City of Pearl, MS
Southeast Sanitary Sewer Improvements (Airport Road)
Pickering Firm, Inc. Project 26917.00

DATE: Monday, 15 November 2024

ADDENDUM #1

SHEET NUMBER:
C4.04

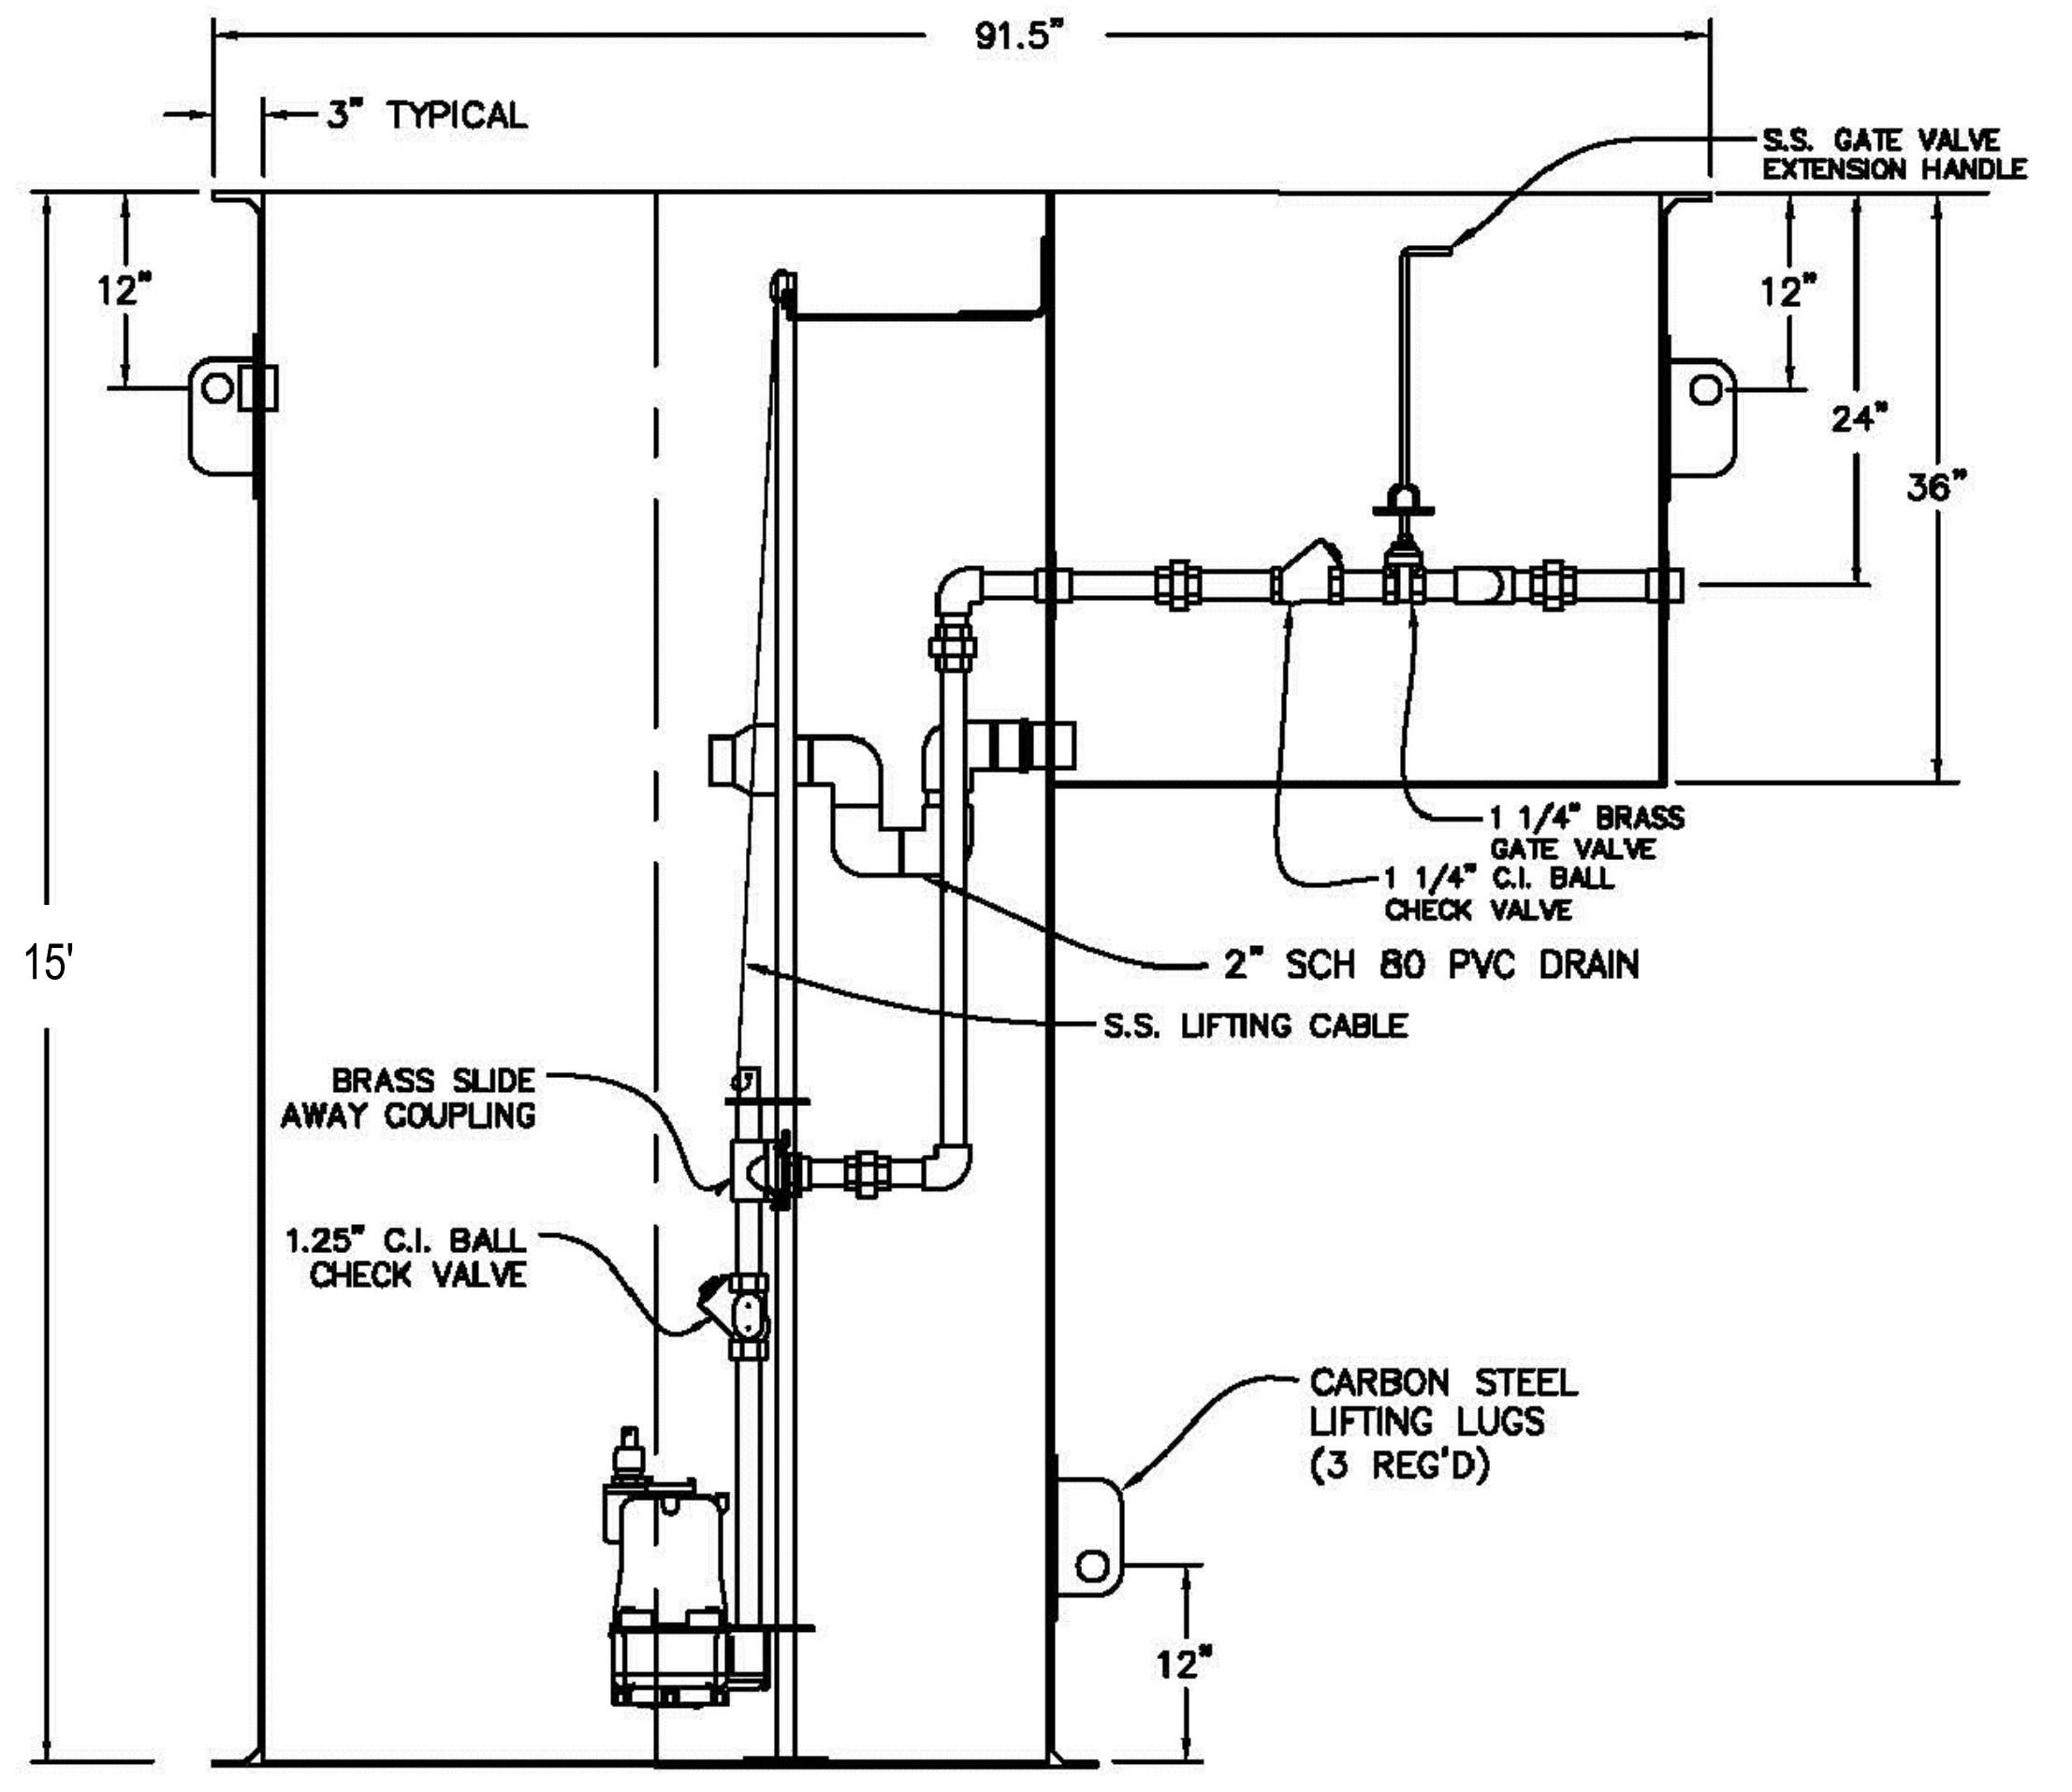
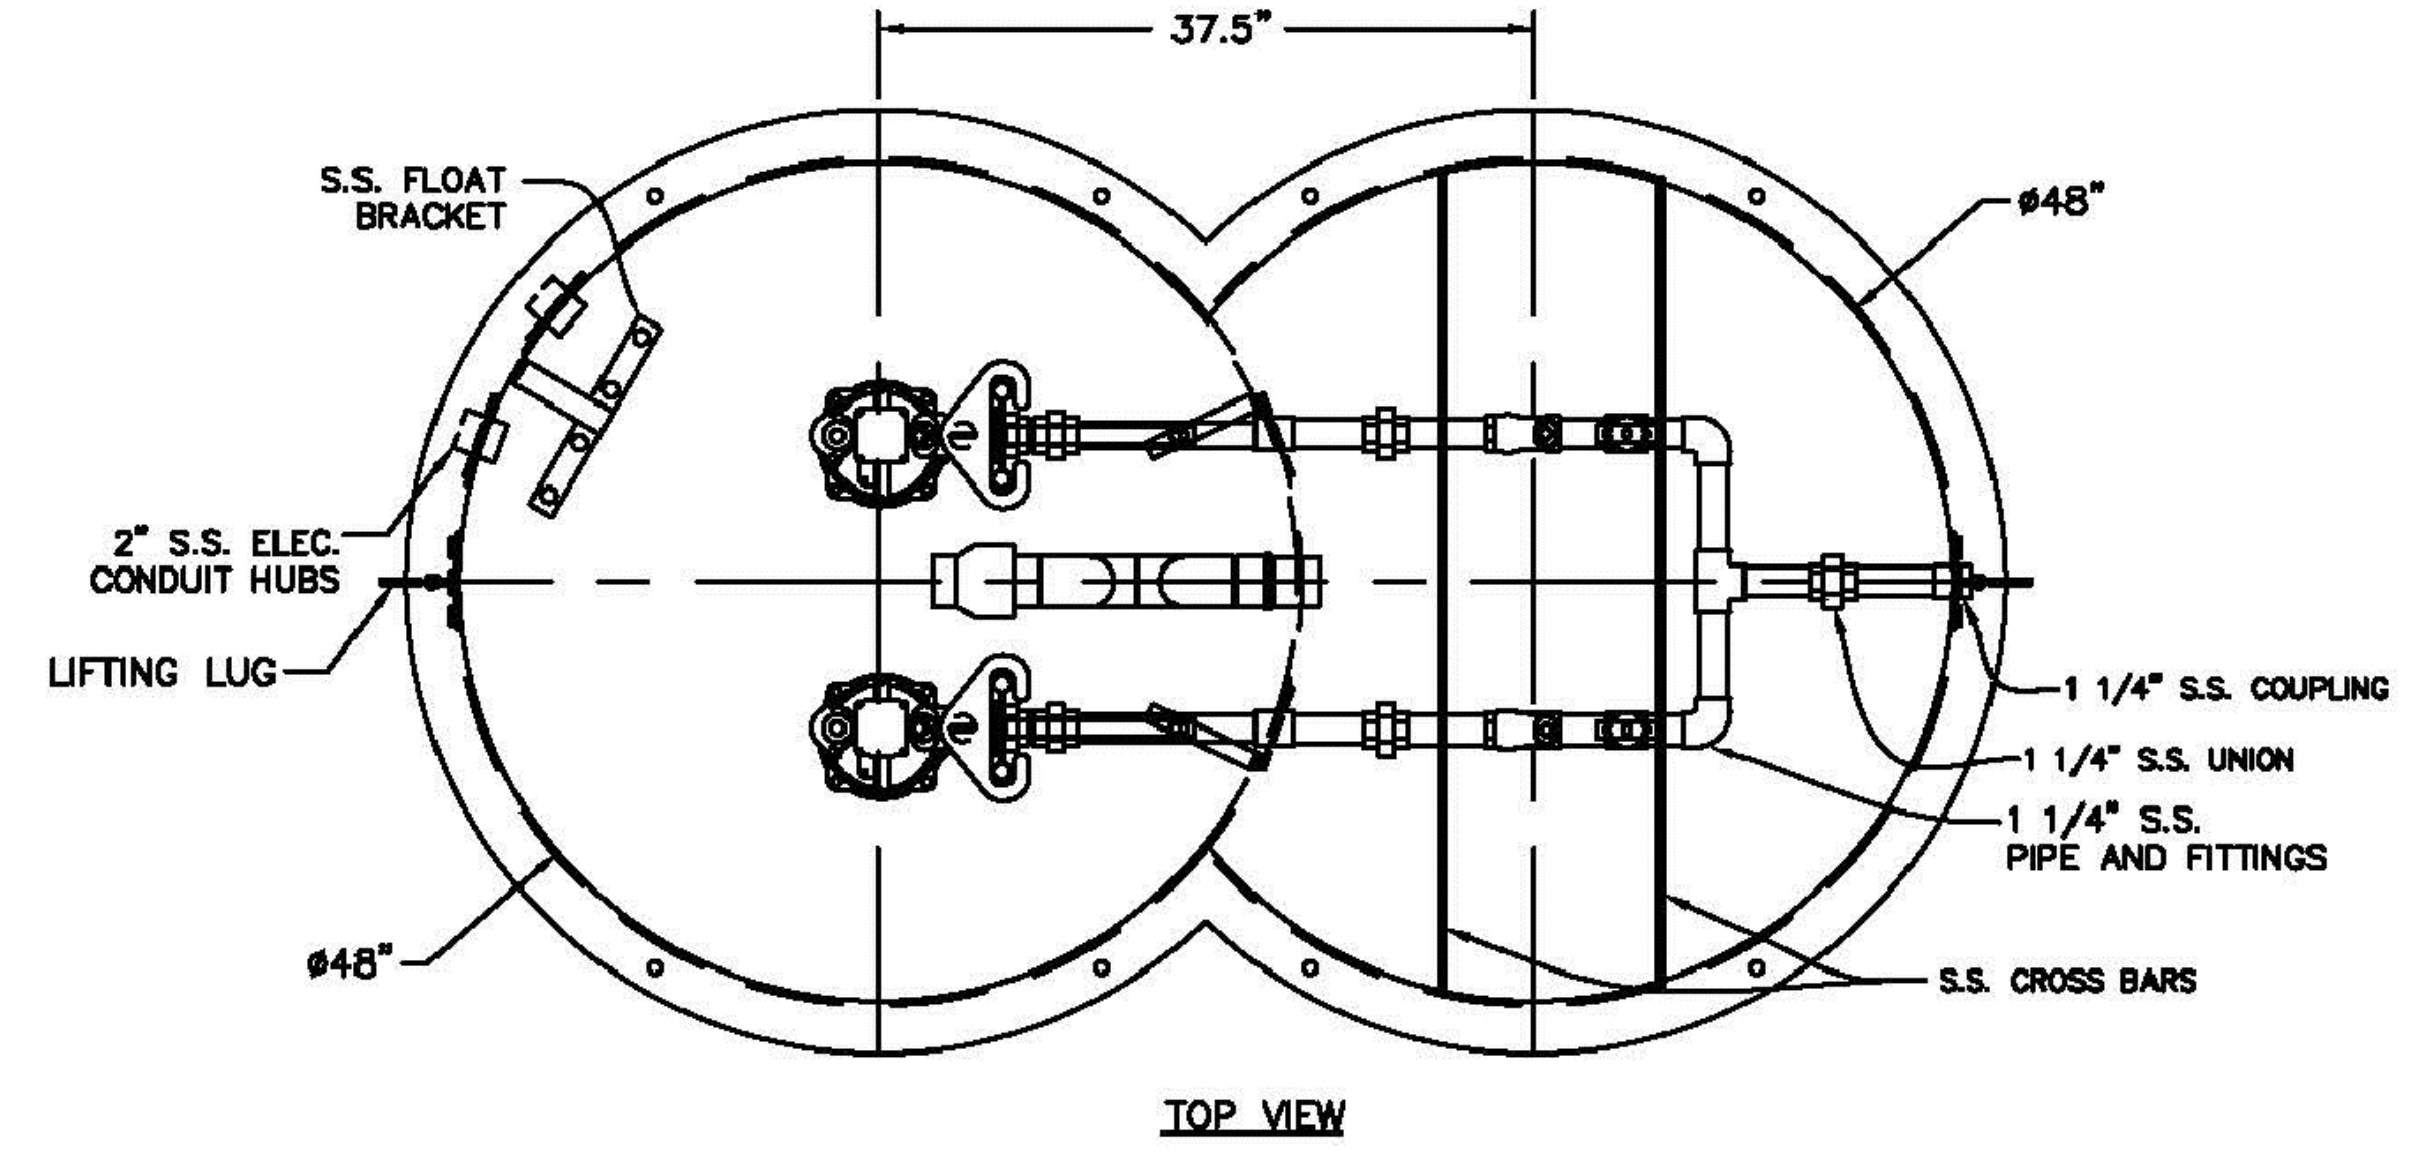
Added Plan Sheet C4.04; grinder pump station details
